Nomad SERVICE BULLETIN

STRUCTURES GENERAL — FASTENERS — IMPROVED RIVETING OF SKINS (MODIFICATION N406 PART A)

NMD-51-1

Figure 8 Landing Gear Pod Skin Rework

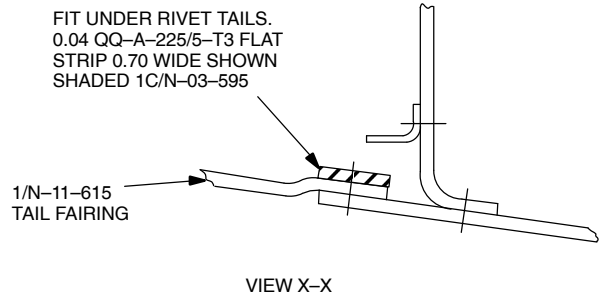
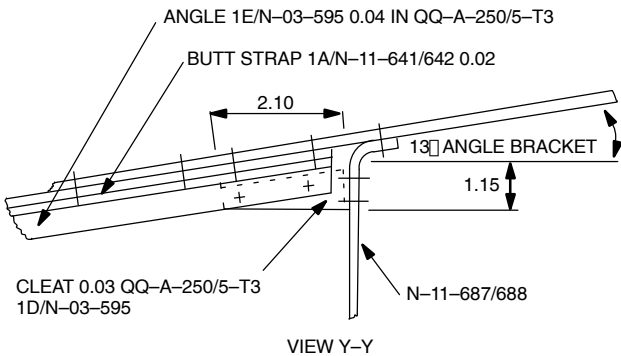
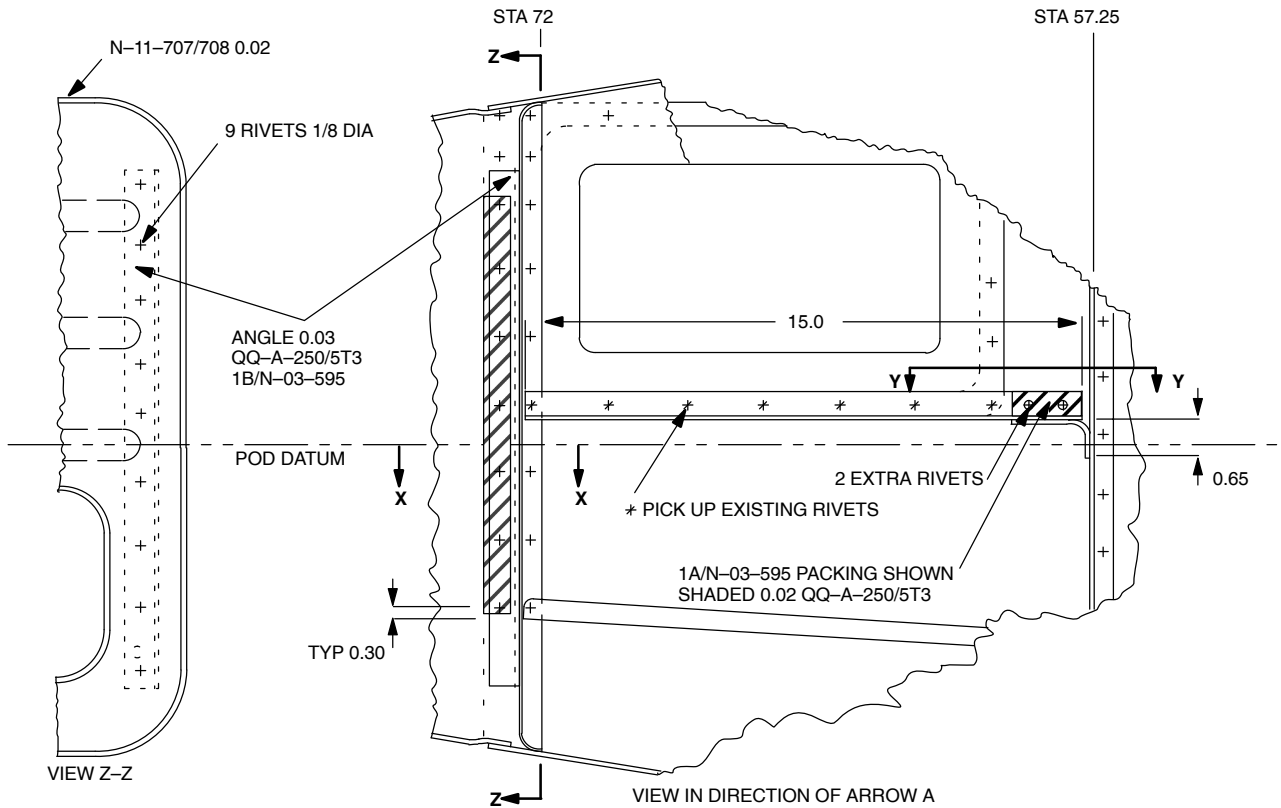
- (1) Remove the aft fibreglass pod fairings to gain access to the aft section of the landing gear pods.
- (2) Install the reinforcing angles P/N 1E/N-03-595 and 1B/N-03-595 as detailed in Figure 8.
- (3) Refit the aft pod fairings reinforcing the attachment rivets using the 0.040 in metal strap as detailed in Figure 8 view X-X. Attach the fairing using solid rivets P/N MS20470AD-4 where possible. CR 3223 cherry rivets or the approved substitutes may also be used.

WHERE POSSIBLE USE MS20470AD 1/8 DIAMETER RIVETS, IF NOT ACCESSIBLE USE AGS 2050 1/8 DIAMETER POP OR MS20600AD 1/8 BLIND RIVETS.
